Access Compliance Report

(Curb Ramps)

Intersection ID: 10036062	Main Street: RIVERGATE_PY	Cross Street: N/A	Location: NE
ADA ID: 122E7C386FDC	Ramp Type: Perp	Initial Pass/Fail: Fail	Overall Compliance: No
Severity Score: 13.75			
Codes/Mitigation Info/Possible Solution		Field Measurements/Component Compliance

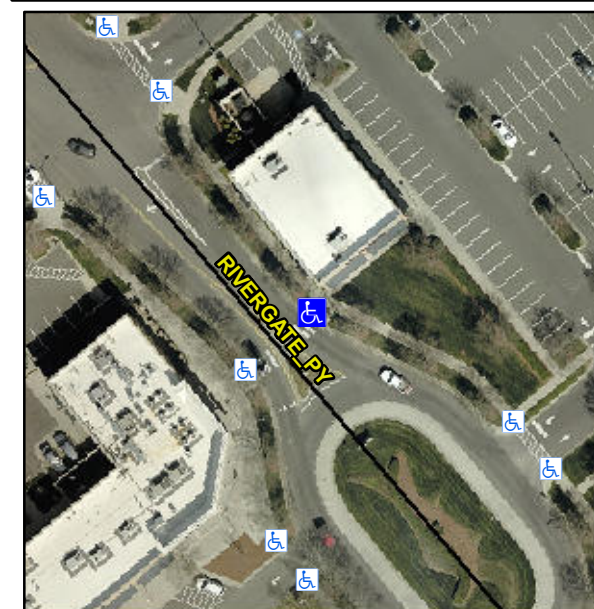
Not Found, R304.2.2, R304.5.3

Compliance	Description	Data	Compliance	Description	Data
N/A	Ramp Length (in)	94.0	No	Ramp Slope (%)	8.5
Yes	Ramp Width (in)	48.0	No	Ramp XSlope (%)	2.4
N/A	Flare Type LT	N/A	N/A	Flare Type RT	N/A
N/A	Flare Slope LT (%)	N/A	N/A	Flare Slope RT (%)	N/A
N/A	Flare Traversable LT?	N/A	N/A	Flare Traversable RT?	N/A
N/A	Landing Length (in)	N/A	N/A	DWS Provided?	N/A
N/A	Landing Width (in)	N/A	N/A	DWS Contrast?	N/A
N/A	Landing Slope (%)	N/A	N/A	DWS Length (in)	N/A
N/A	Landing X Slope (%)	N/A	N/A	DWS Full Width?	N/A
N/A	Landing Curb? (Y/N)	N/A	N/A	DWS Offset (in)	N/A
N/A	Shared Landing?	N/A			
N/A	Gutter Ponding?	N/A	N/A	Gutter Slope (%)	N/A
N/A	Gutter Lip Ht (in)	N/A	N/A	Gutter X Slope (%)	N/A
N/A	Painted X Walk1?	Yes	N/A	Painted X Walk2?	N/A
	X Walk 1 Direction	To SW		X Walk 2 Direction	N/A
N/A	X Walk 1 Width (in)	120.0	N/A	X Walk 2 Width (in)	N/A
	X Walk 1 Slope (%)	2.9		X Walk 2 Slope (%)	N/A
	X Walk 1 X Slope (%)	2.0		X Walk 2 X Slope (%)	N/A

Remove & Replace Entire Ramp.
